N9915A-01

S E R V I C E N O T E

N9915A - FieldFox Handheld Analyzer

Figure 1: No sidebands issue

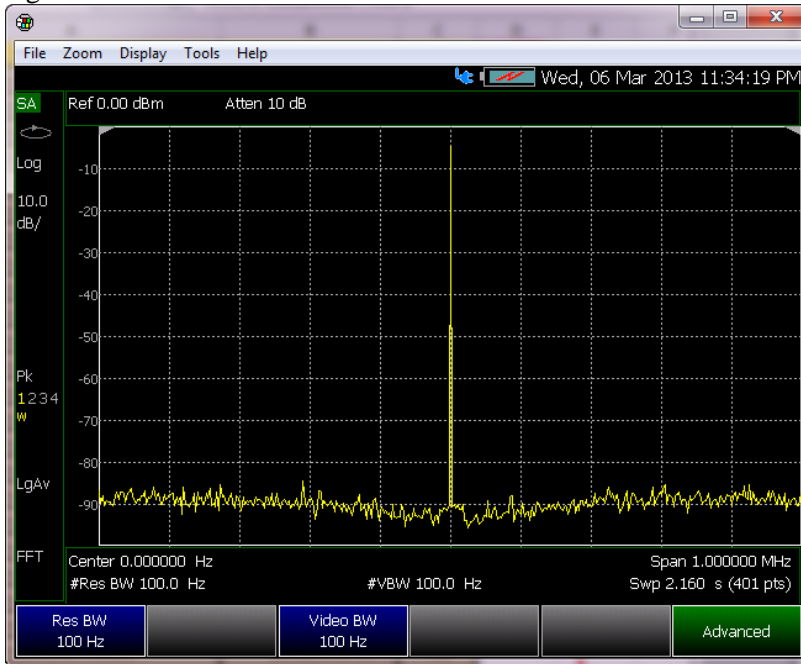
RF board earlier than Rev 7 may have sidebands issue due to oscillation by the voltage regulator. After it is fixed by replacing a new inductor, the RF board revision header will be updated to reflect the change.

Figure 1 shows a good RF signal, and Figure 2 shows FieldFox with sidebands issue.

Affected FieldFox are required to send back to Agilent factory for RF board reliability enhancement. The RF board revision header will be updated to reflect the change. Test and Adjustment shall be done before shipping back to customer.
